#### **WATER2025**

Design Working Group Meeting 6

Tuesday, May 4, 2021

# **Building Shapes Presented in** March

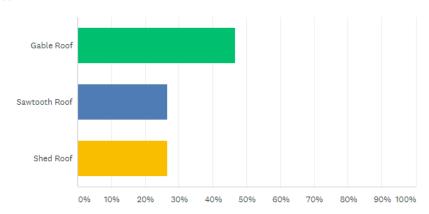
The off-set front door was not appealing. I personally prefer the door being center especially if groups are gathering to tour. To be perfectly honest the off-set door seems to mirror a trailer. It could just be the rendering but that was how it seemed to me. Thanks for listening.

shed roof is	rather	ugly	and	looks	s000000	industrial
--	--------------	--------	------	-----	-------	---------	------------

I am strongly preferring the shed roof since it seems to give the best possibilities for both lighting and an option for later addition of solar panels

It looks like the photo has a combination of roof styles which I think looks very good.

Hate the pre fab metal look on upper part of buildings. None of the forms look good with that. REALLY looks like a garage. I would abstain before I would vote for the metal buildings.

3/8/2021 10:45 PM	View respondent's answers	Add tags 🔻
~	Needs to be solar ready or geo thermal capable		
	3/8/2021 1:08 PM	View respondent's answers	Add tags 🔻
